LETTER OF DEFICIENCY No. WMD LOD 19-132

SUBJECT: North Country Environmental Services, Inc. Landfill

Solid Waste Permit No. DES-SW-SP-03-002

Inadequate Daily Cover

P8150021: Working face located in the western portion of Stage V/Phase II, as viewed from the south and looking in a northerly direction.

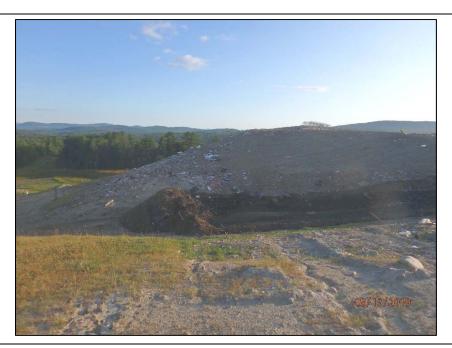
NHDES personnel also inspected the working face located in the southern portion of Stage V/Phase II. NCES staff stated that the last filling at this working face occurred approximately one week prior to the inspection, but that it had been approximately one month since filling in this area had occurred on a regular basis. As such, NCES personnel stated that a combination of daily and intermediate cover was being used in this area. During the inspection, NHDES personnel observed that soil, an approved cover material, was being used as daily/intermediate cover in this area. Additionally, NHDES personnel observed exposed waste throughout the area, as shown in Photographs P8150021 through P8150025.

Assessment: NHDES personnel observed exposed waste during inspection of the working face located in the southern portion of Stage IV/Phase II (see Photographs P8150001 through P8150008), as well as the working face located in the southern portion of Stage V/Phase II (see Photographs P8150021 through P8150025).
